# WisDOT Bridge Manual

## July 2023 Updates

James Luebke, P.E.  
Policy and Standards Engineer  
August 23, 2023

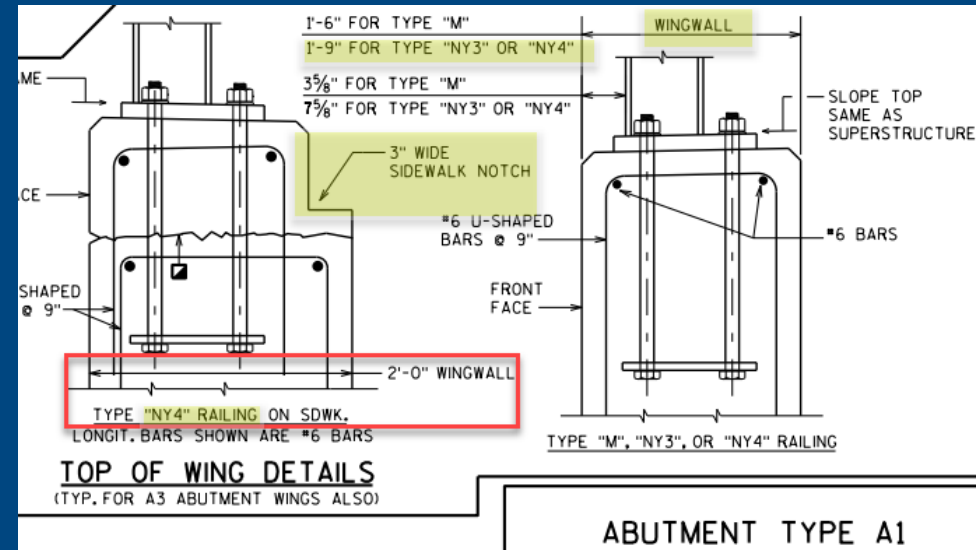
- Std 12.02 – NY4 on Wings
  - Clarified 2'-0" wingwall width with sidewalks
  - 1'-9" wingwall width otherwise
  - Sidewalk → NY4 Railing

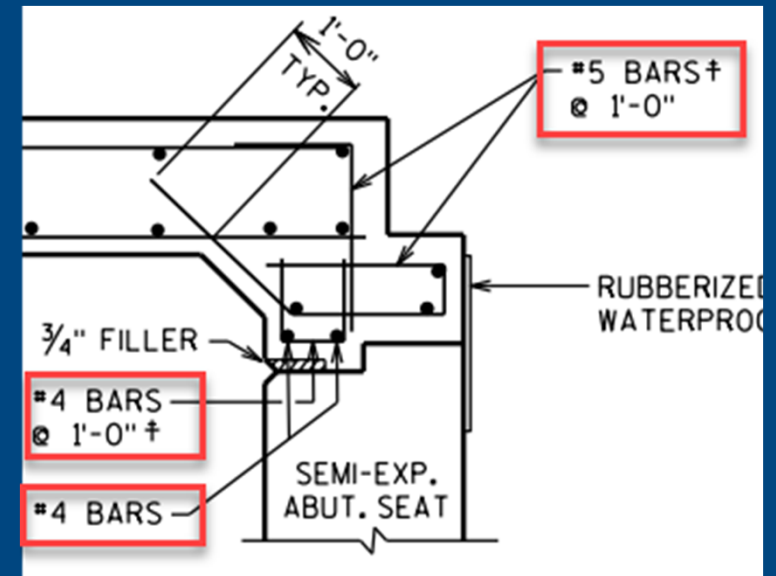
- Std. 18.01 – Abutment Reinforcement
  - #4 bars @ 1'-0" (Seats)
  - #5 bars @ 1'-0" (Paving notch)
  - (2) #4 bars (Seats)
  - Spacing and orientation note

† BARS PLACED PARALLEL TO R.  
SPACING PERPENDICULAR TO R.

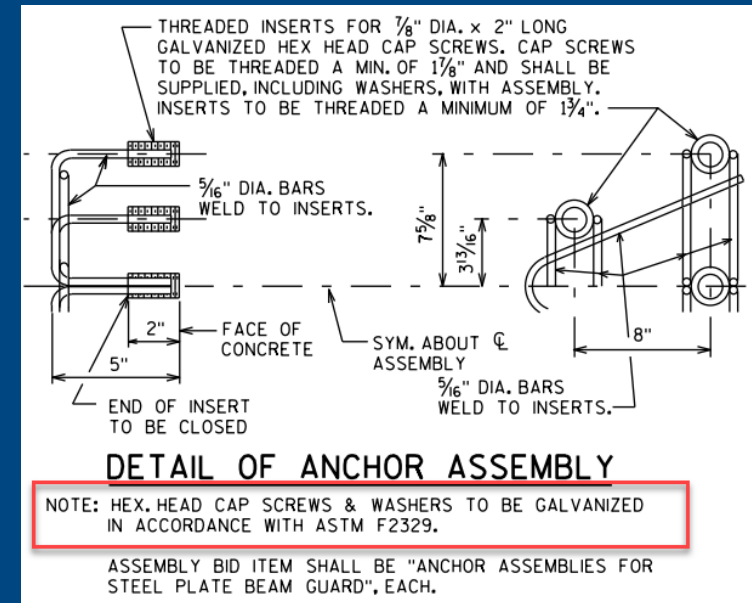
- Std. 30.07 – Detail of Anchor Assembly
  - Updated Caps and Washers to “ASTM F2329”
- **Insert Sheets (Under Development)**
  - Vertical Face Parapet ‘A’
  - Single Slope Parapets
  - Tool Palette - Block

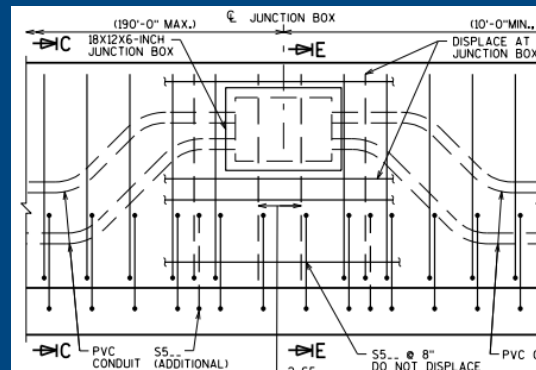
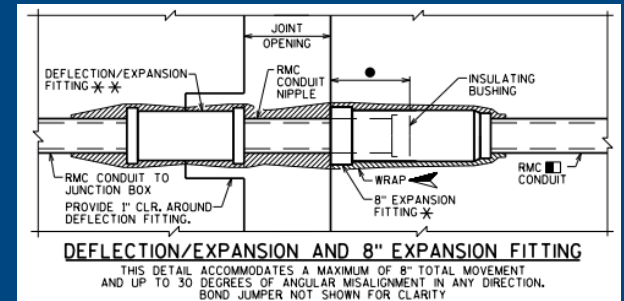
- Chapter 32 – Maximum Allowable Conduit Runs

(2) 2" Conduit Run

Junction Box Coordination

Fittings Coordination

Archived Figure (July 2017)

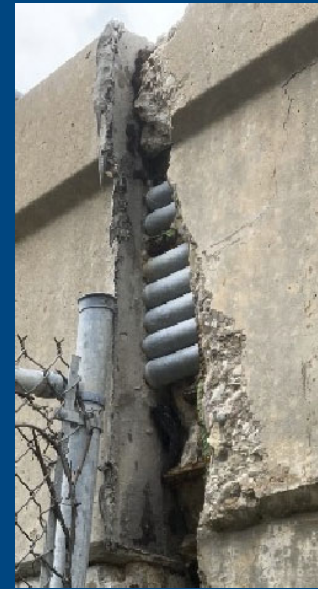
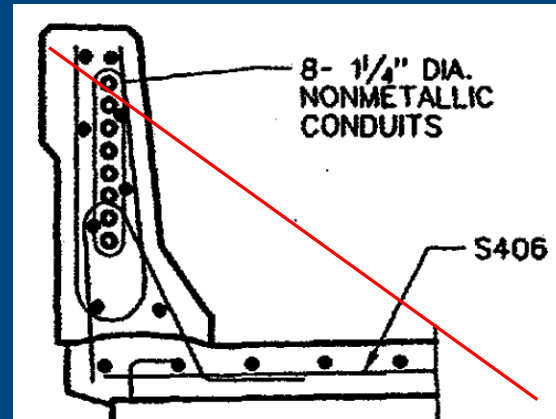
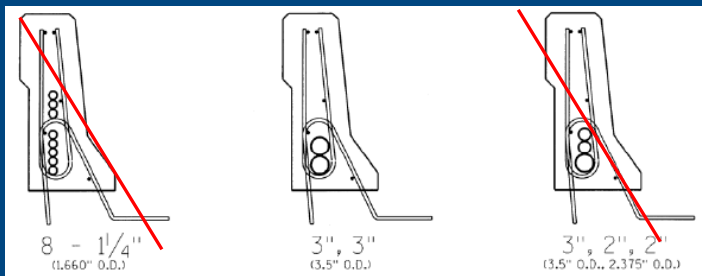
- Chapter 32 – Maximum Allowable Conduit Runs
  - July 2017 – Achieved old details
  - July 2017 – Added (2) 3-inch Dia. max
